Channel Stability Problems, Pajaro River, Watsonville and Pajaro, California

**U.S. Army Engineer Committee on Channel
Stabilization Report of the 63rd Meeting**

ERDC/CHL SR-00-3
CCS-00-1
August 2000

Figure 5. Location map

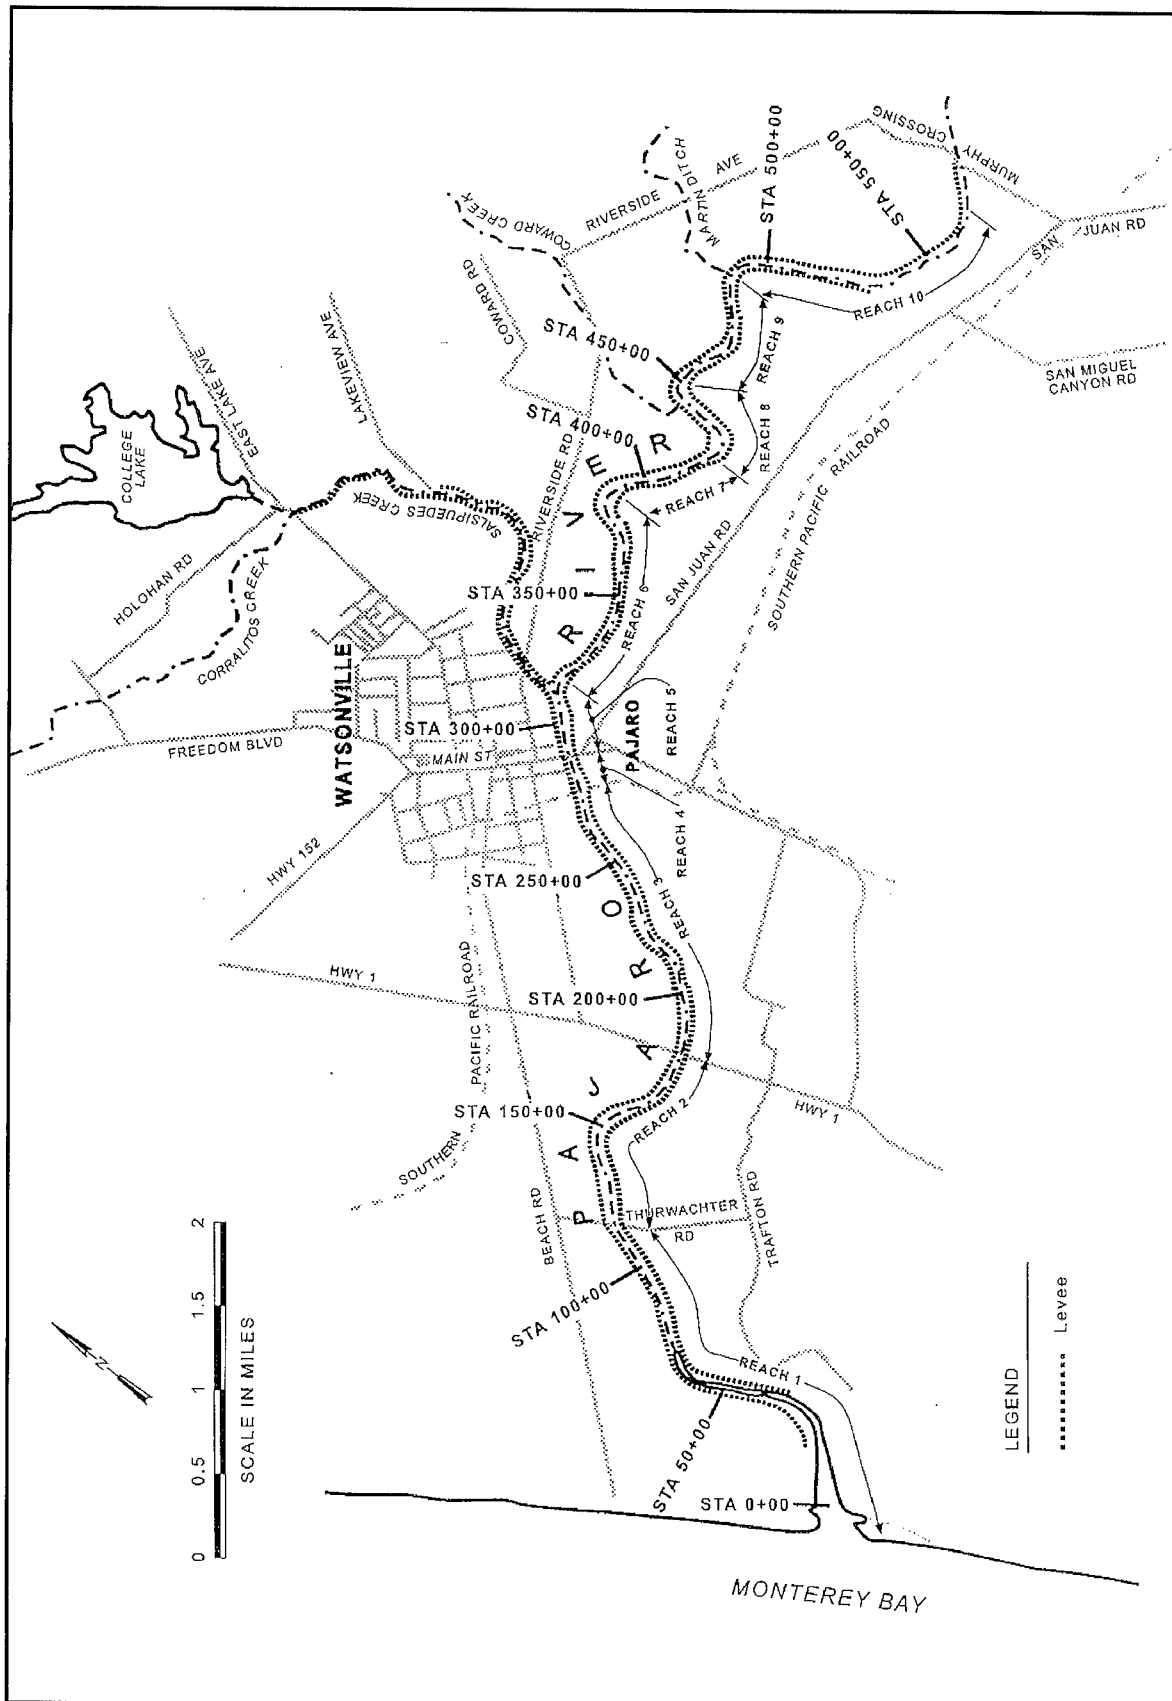
- a. Based upon the information provided in the pre-inspection briefing and field observations, it would appear that the high banks have eroded past the “original” high bank in a relatively few locations. (Figure 5) these are: (1) Sta 132+00 to 142+00 RB; (2) Sta 164+00 to 166+00 LB; (3) Sta 176+00 to 178+00 LB; (4) Sta 219+00 to 224+00 RB; (5) Sta 243+00 to 247+00 LB; (6) Sta 275+00 to 276+00 LB; (7) Sta 296+00 to 297+00 LB; (8) Sta 323+00 to 324+00 LB; (9) Sta 333+00 to 345+00 LB; (10) Sta 374+00 to 376+00 RB; (11) Sta 415+00 to 417+00 LB; (12) Sta 422+00 to 423+00 LB.

Figure 6. Incorrect installation of erosion control mats

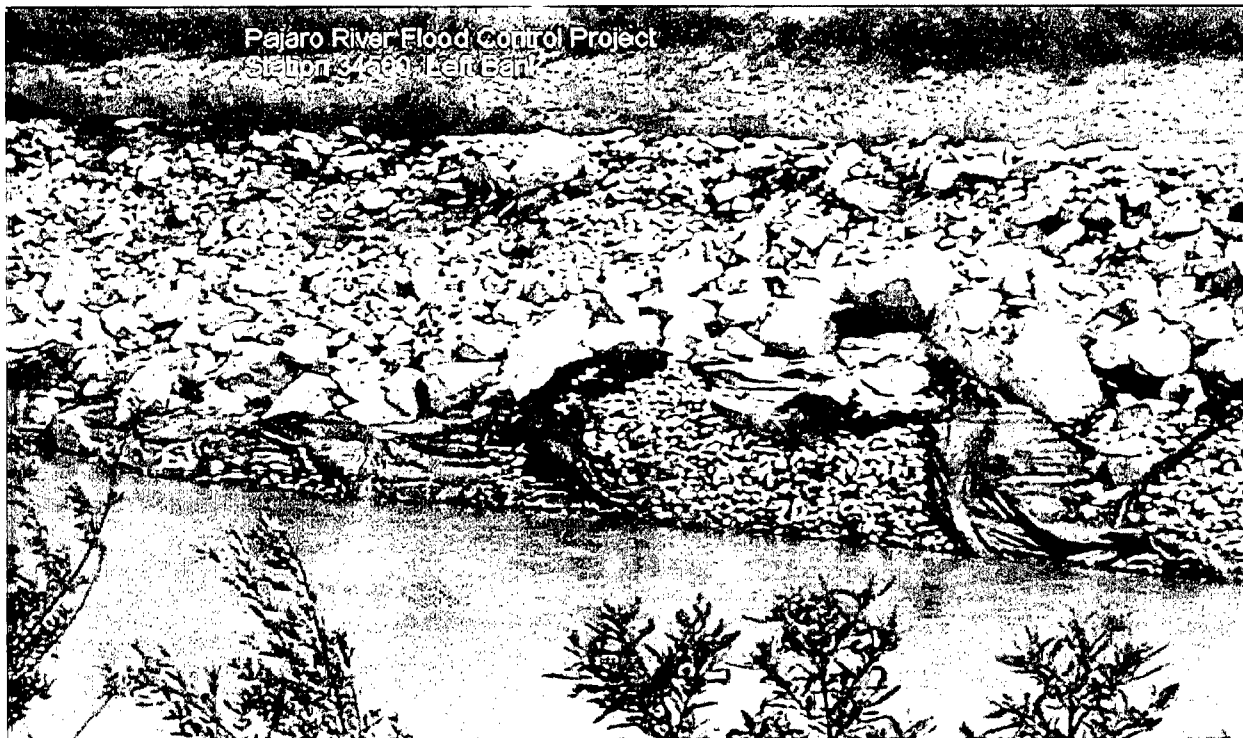
- c. The locations where the banks have been stabilized are very steep. Also, the stone, although apparently well graded, is inconsistent in size. The erosion control mats have been installed incorrectly and/or have been applied to situations for which they were not intended (see Figure 6).

Figure 7. Alternative 1a

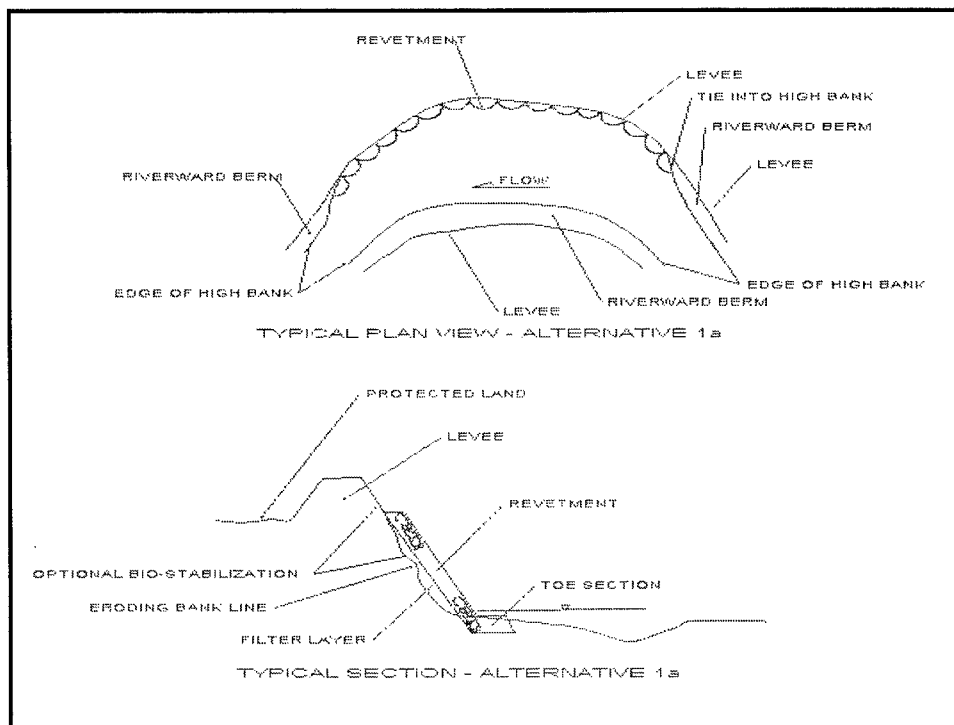
The Committee looked at two different scenarios for bank stabilization: first, where the bank has eroded up to the toe of the levee (within 10 ft); and second, where the bank has eroded to within 30 ft of the levee toe. For the first case the Committee developed three alternatives for stabilizing the banks (Figures 7 and 8). Alternatives for the second case are shown in Figure 9.

- a. Of the alternatives for stabilizing the banks that have eroded to the toe of the levee, Alternative 1b (peak stone revetment with horizontal tie backs) is my recommended plan. This alternative will provide protection for the toe of the bank without promoting excessive deposition. However, there are risks associated with leaving a vertical bank adjacent to a levee. These risks included subsequent geotechnical failures, continued erosion during prolonged high-flow events, and decreased seepage paths. To counter some of these impacts, biostabilization could be employed above the horizontal tiebacks, or every second or third tieback could be a sloping tieback. The tiebacks should be perpendicular to the peak stone revetment, and should be spaced at 100-250-ft intervals depending on the degree of curvature in the bend. The tighter the bend the closer the spacing.

Figure 8. Alternative 1b and 1c

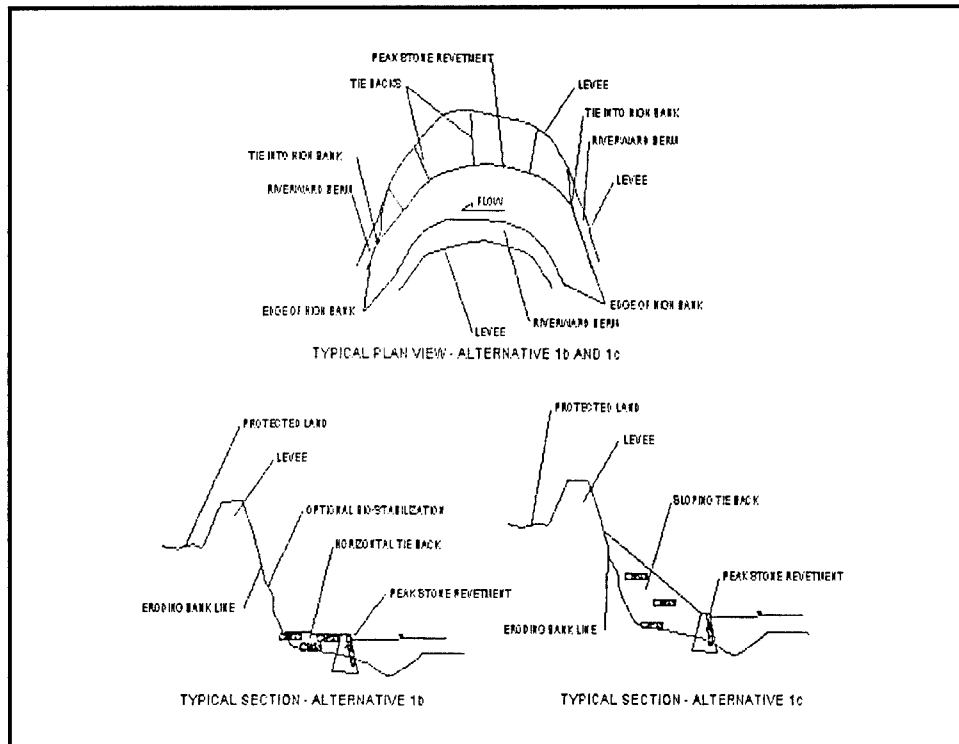
The peak stone revetment and tiebacks are shown in the figures as being constructed of stone, and this is the preferred method due to long-term reliability. However, the structures could be constructed of woven wire
